Licence Number	L8769/2013/1
Licence Holder	River Nominees Pty Ltd
ACN	109 054 239
File Number:	2013/003438-2
Premises	Purearth Woottating Facility 324 Horton Road WOOTTATING WA 6562 Legal description – Lot 13 on Diagram 87525 Certificate of Title Volume 2026 Folio 553
Date of Report	18/03/2020
Decision	Amendment granted

2. Amendment Description

2.1. Purpose and scope of assessment

Figure 1: Layout of HDPE panels and welds for the new 1,000 kL leachate pond. (Source: Purearth Woottating Composting Facility - QA/AS Built Details)

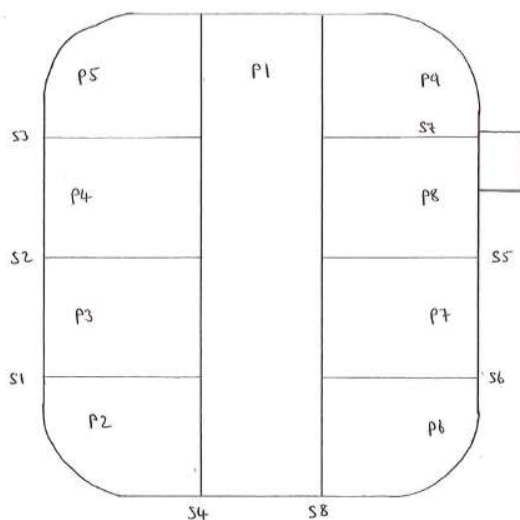
The Delegated Officer notes that:

1. Installation of the pond was not in accordance with any instrument or conditions, however the pond design meets the general requirements for similar infrastructure stipulated in other works approvals and licences.
2. CQA documentation indicates that the leachate pond was installed with no defects and is suitable for use at the Premises.

Figure 2: Modelled cumulative volume of leachate within the combined leachate ponds across three years. (Source: Purearth Woottating Composting Facility - Water Balance Report)

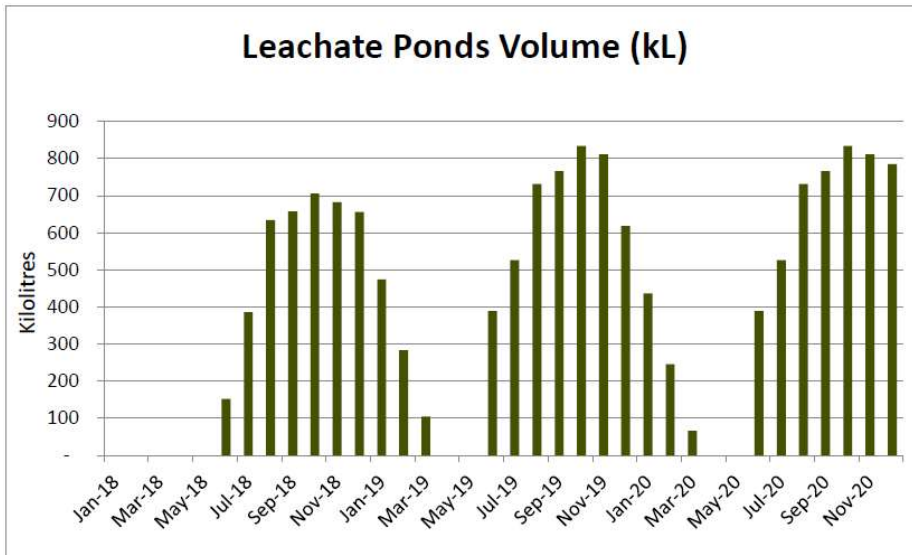
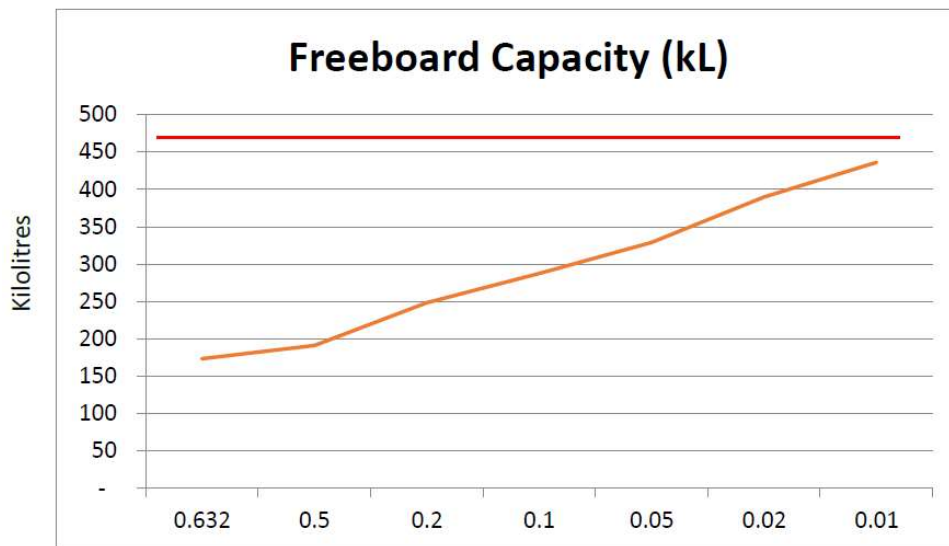
The Delegated Officer notes that:

1. Various errors have been made with the parameter inputs listed in the water balance assessment such as;
 - a. Leachate pond freeboard was input as 0.5 m instead of 0.6 m. With a freeboard height of 0.6 m the ponds have a combined freeboard capacity of 562 kL. This results in a combined pond capacity of 1,258 kL excluding freeboard;
 - b. Pan evaporation measurements for the Chidlow weather station (9007) do not exist. The Bureau of Meteorology (BoM) website lists the station as not having ever recorded pan evaporation measurements. The nearest listed weather station (Bakers Hills 10244) with available evaporation data only has records between 1965-1985; and

- c. Average evaporation rates used in the water balance are significantly lower than those displayed in average evaporation mapping produced by BoM and the values in the initial licence application (Bowman 2012). BoM data shows that average annual evaporation rates for the area are higher than annual rainfall volumes and approximately 7 times higher than the rates listed in the water balance.

2. Water balance modelling using undervalued evaporation rates indicates yearly cumulative volume in the leachate ponds would not exceed a maximum of 850 kL, based on full leachate usage in the compost process each year.

3. The incorrect average evaporation rates would result in over-calculation of the volume of leachate generated and captured at the Premises.
 4. 850 kL represents a highly conservative estimate of maximum leachate volume and is well below the combined leachate pond capacity of 1,258 kL excluding freeboard.

5. Despite errors in the water balance calculation, the Licence Holder has demonstrated that sufficient capacity exists within the leachate ponds at the Premises, both under normal conditions and during rainfall events.
